Access Compliance Report

Public Rights-of-Way

(Curb Ramps)

Intersection ID: 10033071	Main Street: NORTH_COMMUNITY_HOUSE_RD	Cross Street: N/A	Location: S
ADA ID: 977638BD7D83	Ramp Type: Para	Initial Pass/Fail: Fail	Overall Compliance: No
		Severity Score: 12.5	
Codes/Mitigation Info/Possible Solution		Field Measurements/Component Compliance

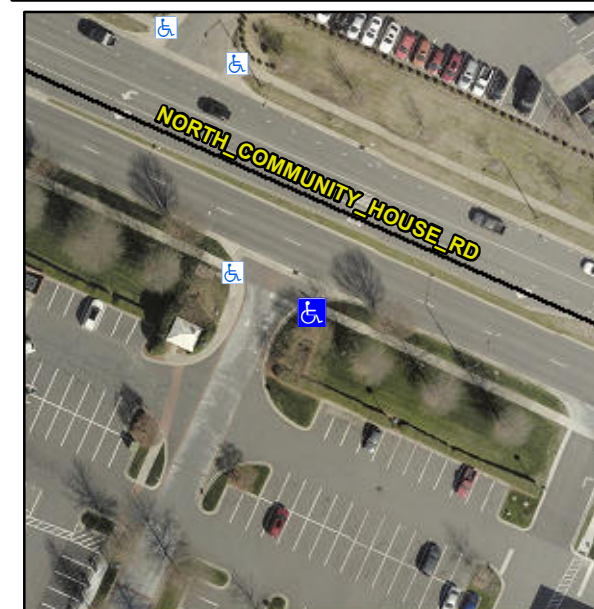
R304.3.2

Compliance	Description	Data	Compliance	Description	Data
N/A	Ramp Length LT (in)	28.0	N/A	Ramp Length RT (in)	62.0
Yes	Ramp Width LT (in)	84.0	Yes	Ramp Width RT (in)	75.0
Yes	Ramp Slope LT (%)	7.7	No	Ramp Slope RT (%)	11.1
Yes	Ramp XSlope LT (%)	1.1	Yes	Ramp XSlope RT (%)	1.4
N/A	Landing Length (in)	N/A	N/A	DWS Provided?	N/A
N/A	Landing Width (in)	N/A	N/A	DWS Contrast?	N/A
N/A	Landing Slope (%)	N/A	N/A	DWS Length (in)	N/A
N/A	Landing X Slope (%)	N/A	N/A	DWS Full Width?	N/A
N/A	Landing Curb? (Y/N)	N/A	N/A	DWS Offset (in)	N/A
N/A	Shared Landing?	N/A			
N/A	Gutter Ponding?	N/A	N/A	Gutter Slope (%)	N/A
N/A	Gutter Lip Ht (in)	N/A	N/A	Gutter X Slope (%)	N/A
N/A	Painted X Walk1?	No	N/A	Painted X Walk2?	N/A
	X Walk 1 Direction	To NW		X Walk 2 Direction	N/A
N/A	X Walk 1 Width (in)	N/A	N/A	X Walk 2 Width (in)	N/A
	X Walk 1 Slope (%)	0.0		X Walk 2 Slope (%)	N/A
	X Walk 1 X Slope (%)	2.3		X Walk 2 X Slope (%)	N/A
N/A	Ramp inside XWalk1?	N/A	N/A	Ramp inside XWalk2?	N/A

Remove & Replace Entire Ramp.
